**NorthConnex Environmental Impact Statement - submission on behalf of Bunnings**

## **Impacts of construction heavy vehicle access/egress to the Trelawney Street Compound(C7)**

Figure 7-5 Trelawney Street construction compound spoil haulage routes

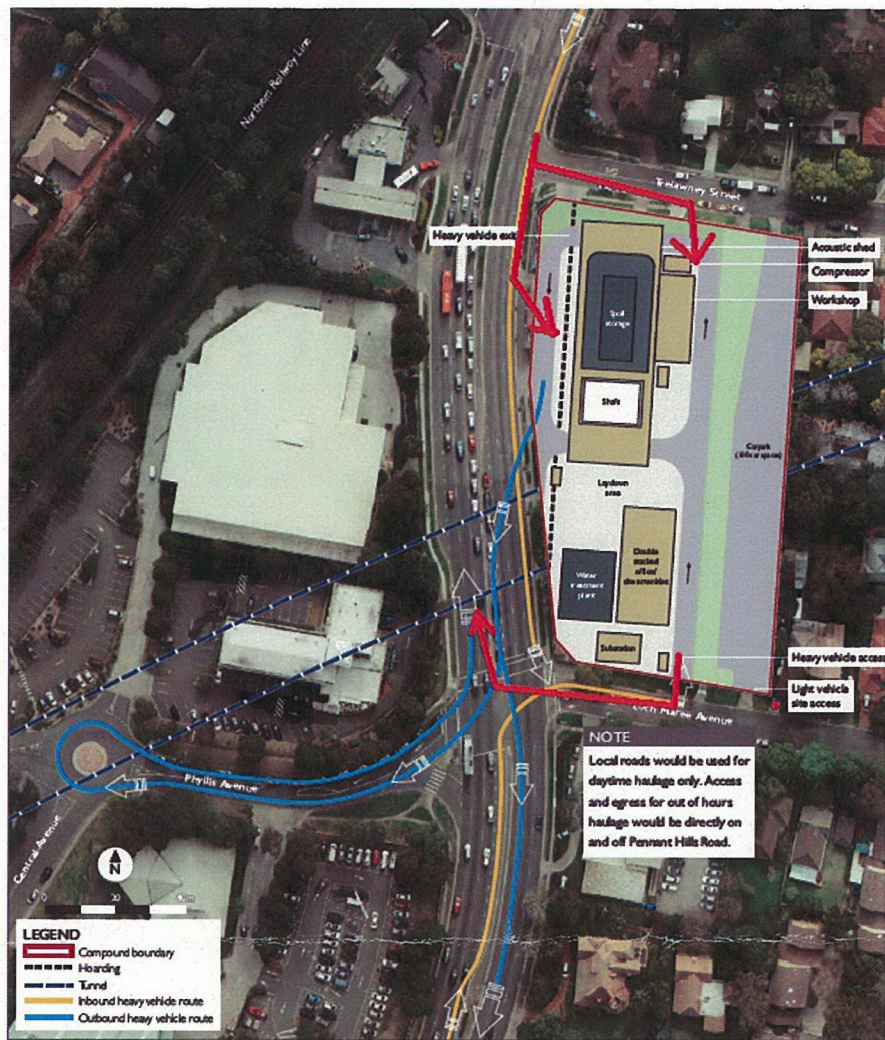
It is proposed that fully laden articulated spoil haulage construction vehicles from a standing start will need to cross three lanes of south bound Pennant Hills Road traffic to wait at the traffic lights in a slip lane that is approximately 70 metres long. Bunnings believes this provides an unsafe and impractical outcome for all road users and creates two turning movements that appear unnecessary.

Bunnings suggests that proponents investigate an outcome whereby construction vehicles enter Trelawney Street compound via a left in directly off Pennant Hills Road and exit the compound onto Loch Maree Avenue followed by a direct right hand turn onto Pennant Hills Road to head north. This intersection could be further controlled with phased traffic lights to separate local traffic and construction vehicles on Loch Maree Avenue.

This proposed solution provides that construction vehicles will queue within the compound waiting to head north on Pennant Hills Road rather than queuing in two critical turning bays on Pennant Hills Road and Phyllis Avenue. See below mark-up of the spoil haulage routes figure below indicating an alternative design via red arrows.
